# SAFETY ALERT

## Product Safety Bulletin No. 2

GDM Top Drive 500/650 Ton and GDM Top Drive 750/850 Ton

Grabber Cylinder Plate, Strap, Retainer (Reference drawings A500175, A500345, A800029, A800345)

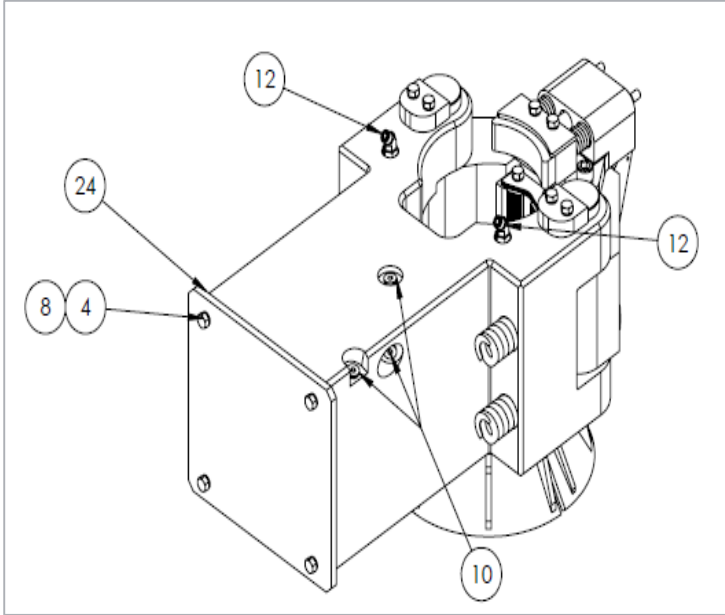
GDS received a report of an incident involving the bolts (P/N 008121.0824DH2), washers (P/N 220102.0800), and Plate, Strap, Retainer (P/N M500481) coming loose. No injuries occurred as a result of the incident.

GDS recommends inspecting the Plate, Strap, and Retainer for damage, looseness or missing hardware on all units. If anything is found missing, it is important to replace and resecure. If broken wires are found, check the affected bolt for tightness and rewire. If it is determined that more immediate repairs are required, please contact the GDS Service Department.

A100807 Secondary Restraint Kit installed on GDM Grabber Assembly

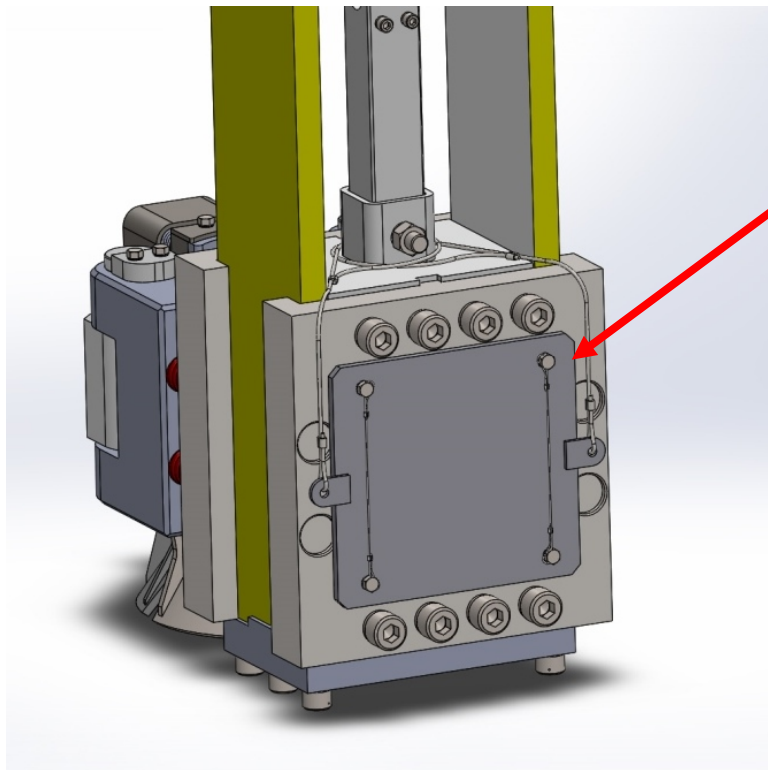
In this rendering of the original configuration, **Item 24** does not come with any means of secondary retention.

A secondary restraint kit (P/N A100807) has been developed and is available from GDS. Customers should order this kit to ensure the correct secondary retention parts are used.
